PLANNING COMMISSION MEETING AGENDA

SUBJECT: **Site Plan Review #7 – Jack Livingstone, Tree Fellers Wood Products & Furniture
2017 North Burdick**

DATE: September 26, 2023

SUBJECT: **Site Plan Review #6 – Jack Livingstone, Tree Fellers Wood Products & Furniture 2017 North Burdick**

Sheet Number
A-08

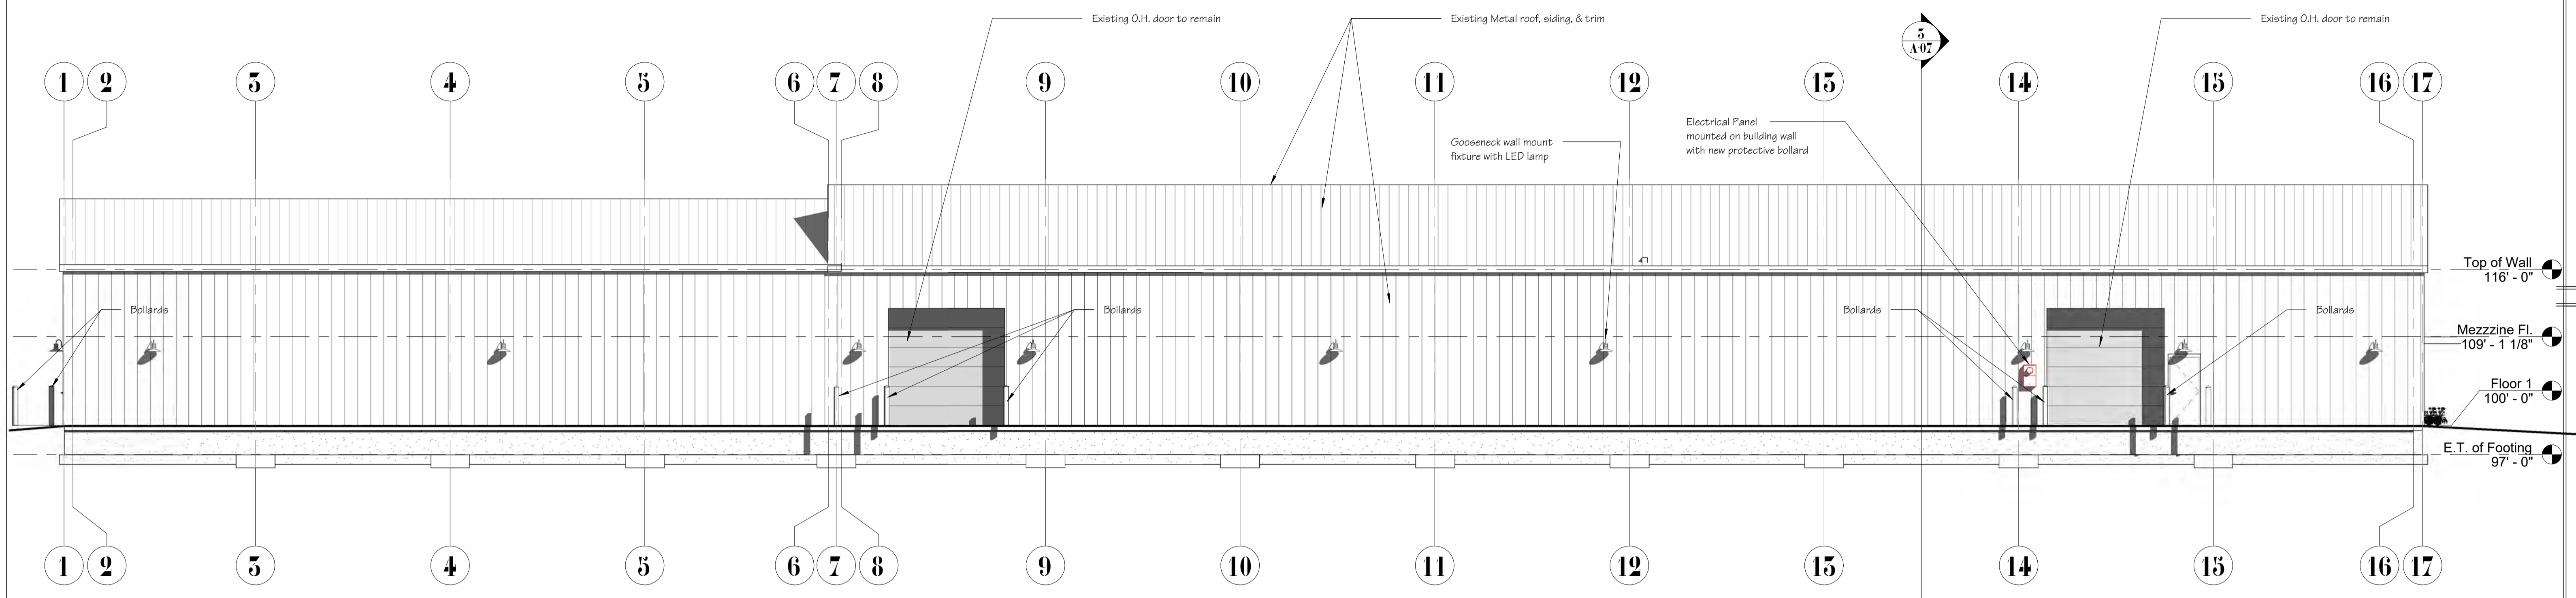
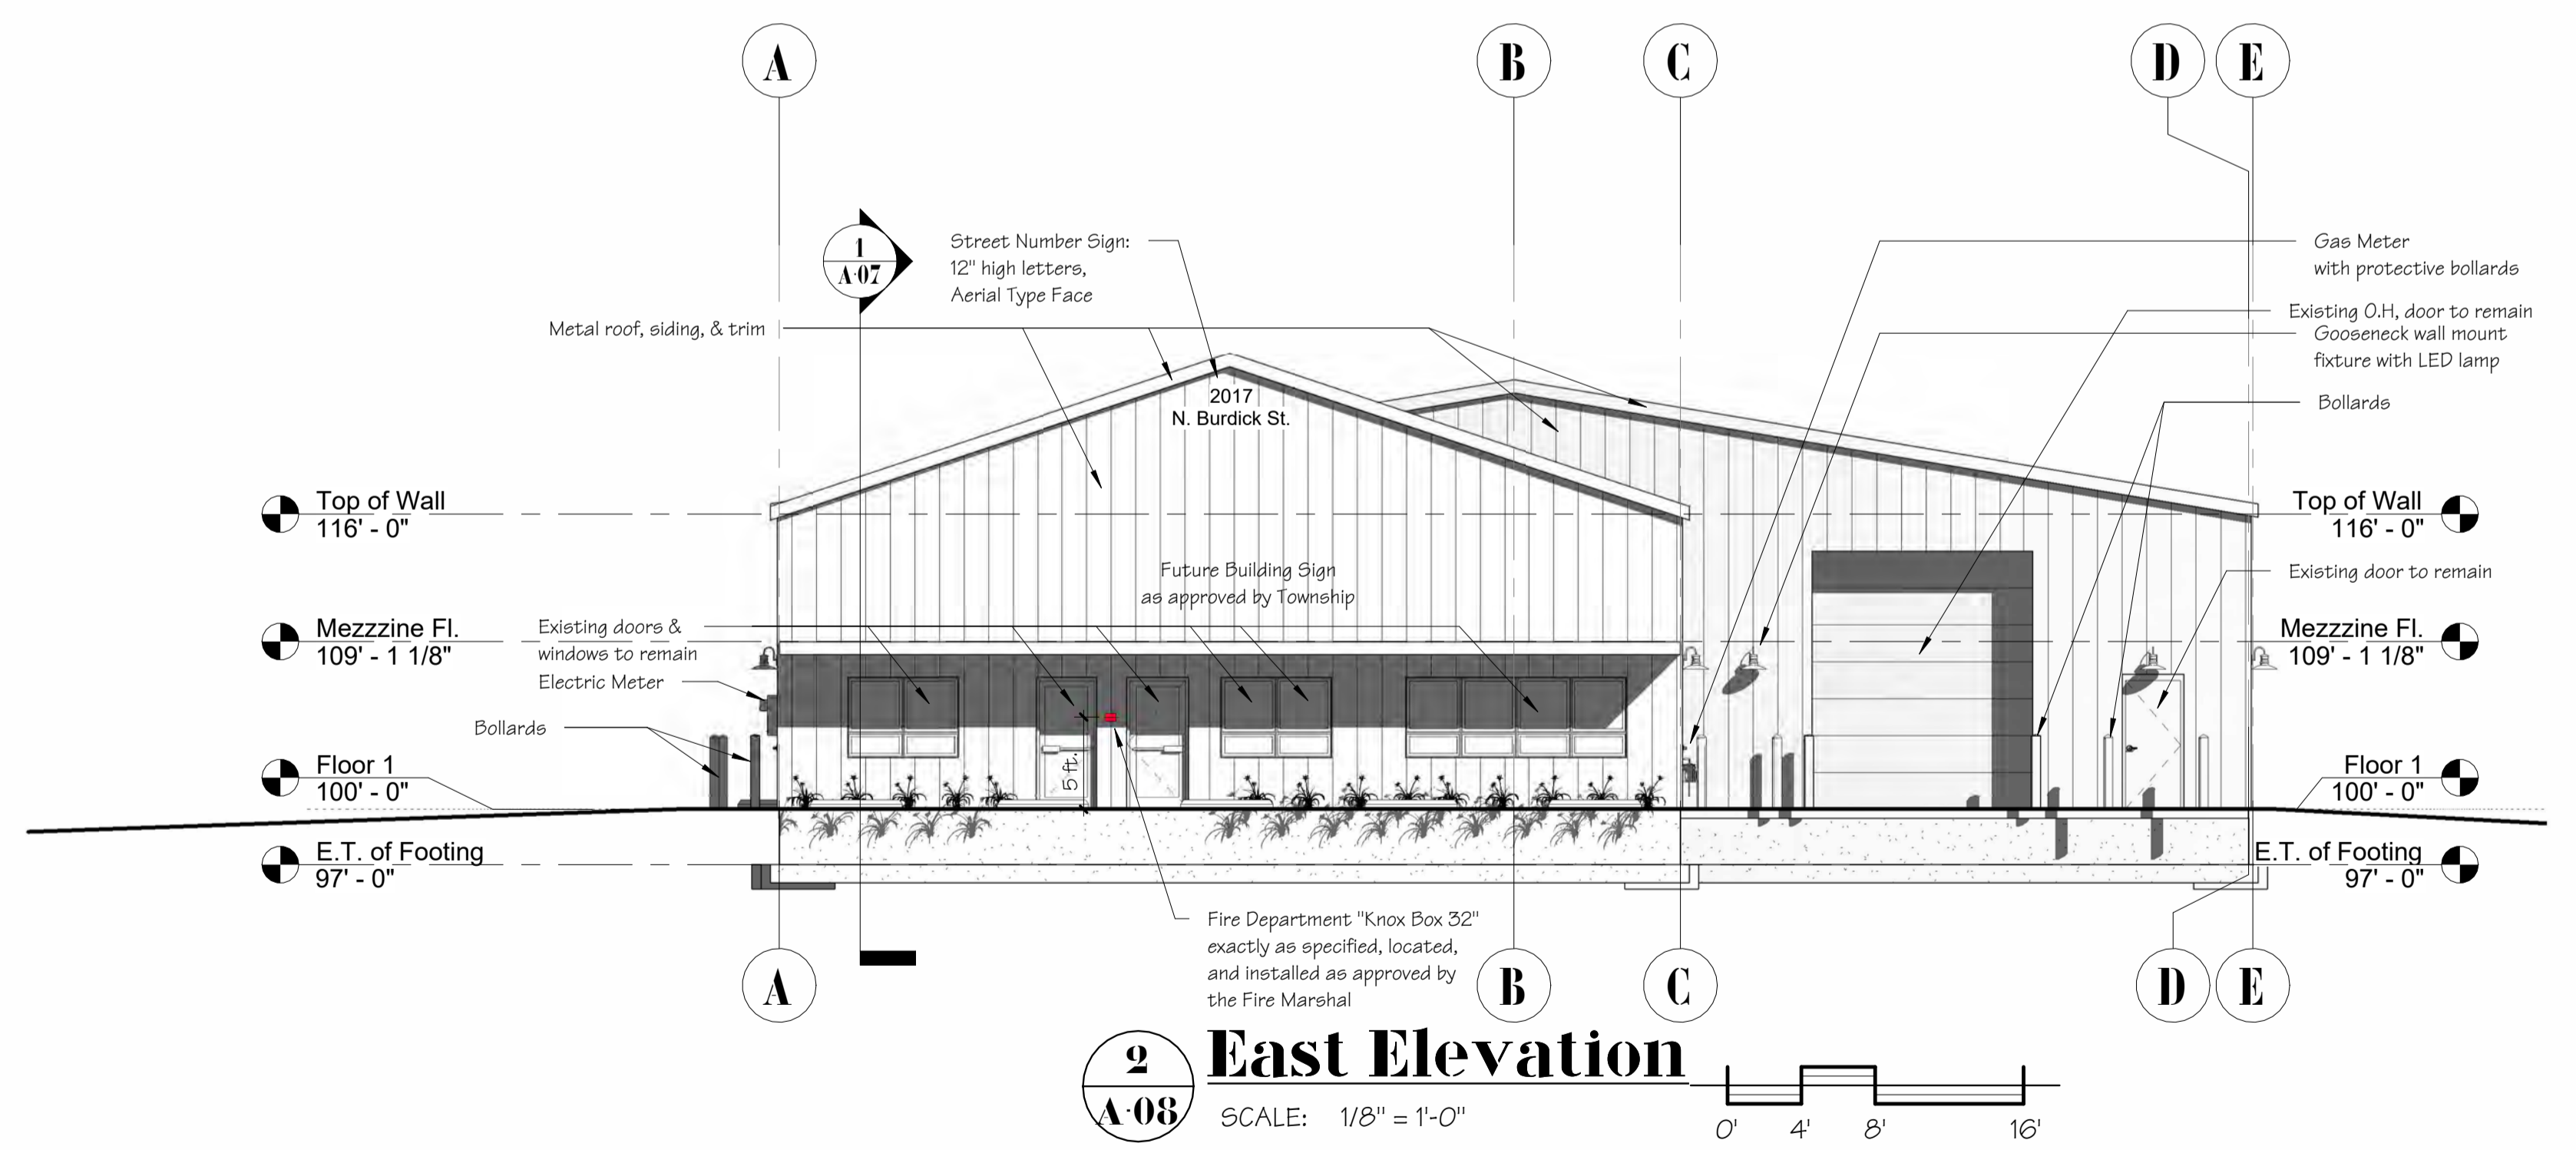
Signage See exterior sign on east elevation drawing for location, sheet A-08. The applicant has not provided any details pertaining to site signage. Site signage can be reviewed and addressed administratively, should the applicant seek to pursue signage at a later date.

See exterior sign on east elevation drawing for location, sheet A-08. The applicant has not provided any details pertaining to site signage. Site signage can be reviewed and addressed administratively, should the applicant seek to pursue signage at a later date.
